TECHNICAL RESPONSE TO ITEMS 5, 6, AND 7
ORDER R-8161-A
OIL CONSERVATION DIVISION
as pertains to Application for Permit by
PETRO-THERMO CORPORATION
by

**Geohydrology
Associates, Inc.**

prepared for
POLLUTION CONTROL, INC.
and
SNYDER RANCHES, INC.

September 16, 1986

Figure 1 - Location Map

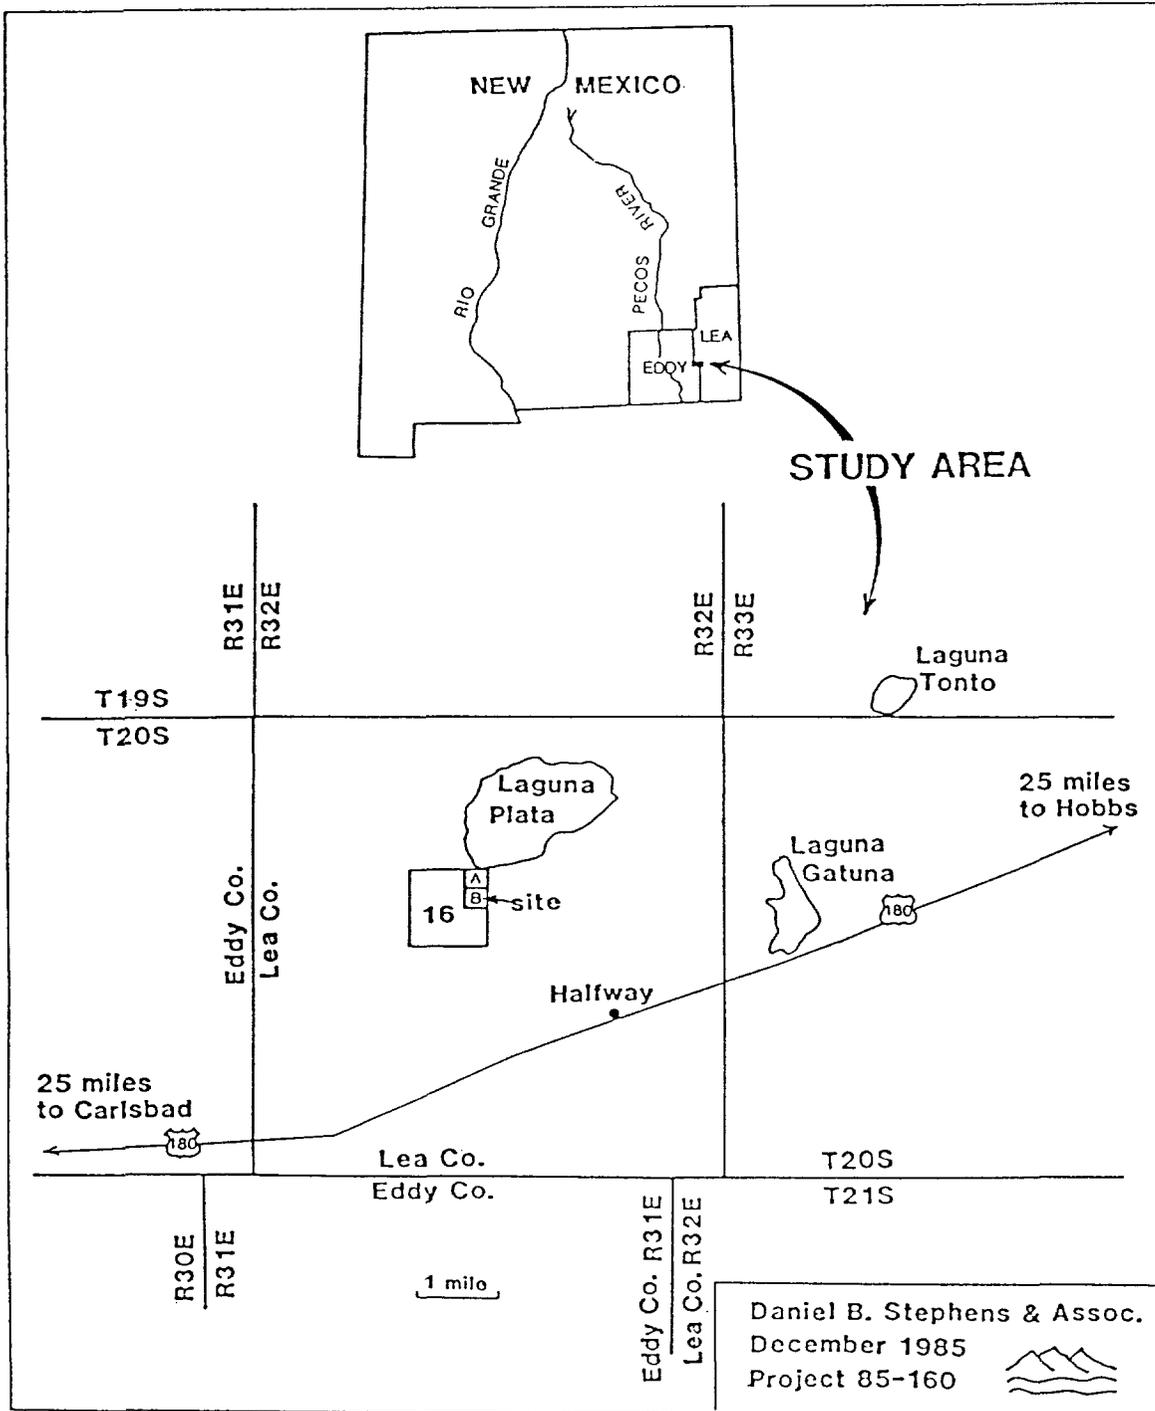
The Petro-Thermo Corporation has submitted an application to construct a disposal facility for waste materials from oil and gas field operations, including produced salt water and solid wastes. This facility would be located on lands owned by the State of New Mexico in the SW/4 SE/4 NE/4 of Section 16, T. 20 S., R. 32 E., NMPM, Lea County, New Mexico (fig. 1).

Figure 2

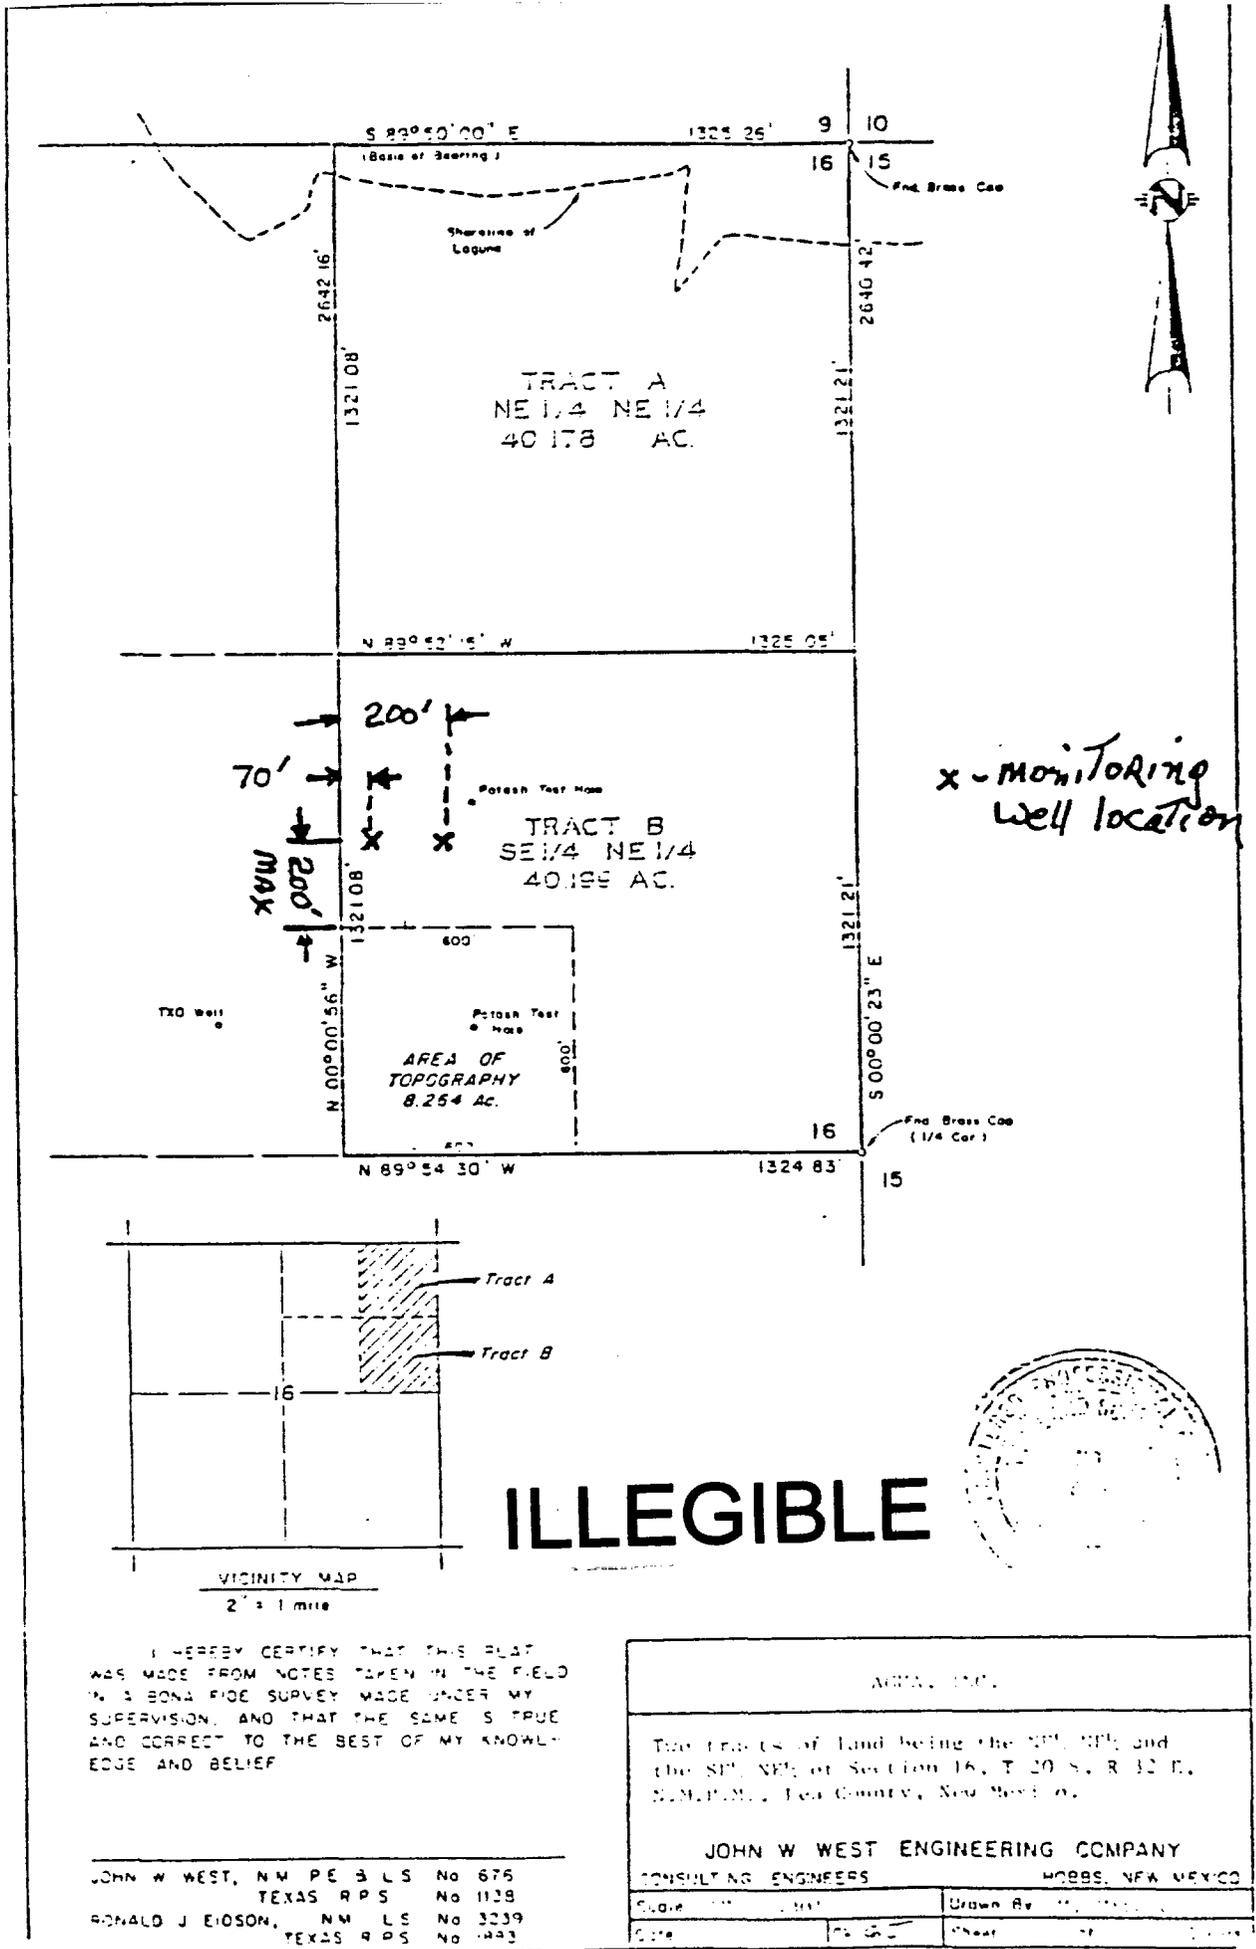
Testimony has been presented by Petro-Thermo Corporation which assumes that the configuration of the "redbeds" is similar to that of the surface topography; they have further assumed that the water table in the alluvium slopes in the same direction as the surface topography. They have also assumed that Laguna Plata is located in a closed depression and that there is no outflow from Laguna Plata. Although all of these assumptions have been made in a report prepared by Daniel B. Stephens and Associates of Socorro, New Mexico, to Petro-Thermo Corporation, no supporting documentation has been presented to support these assumptions.

It is noteworthy that earlier testimony before the Oil Conservation Division does not support the assumptions of Petro-Thermo Corporation. In Case No. 4047 (March 19, 1969), documentation was submitted which shows that Laguna Plata is not a closed depression; rather there is outflow toward the west and into Nash Draw and the Pecos River. This study was made in February 1969 by Ed Reed and Associates. Further, detailed studies by Geohydrology Associates, Inc., in 1978, 1979, and 1984 referred to by Petro-Thermo Corporation do not support these assumptions. In fact, Figure 3 of the 1984 report clearly shows that Laguna Plata is not a closed depression, and that the ground-water movement is different from that

suggested by Petro-Thermo. This illustration and information were presented before the Division as Case No. 8292 on August 8, 1984.
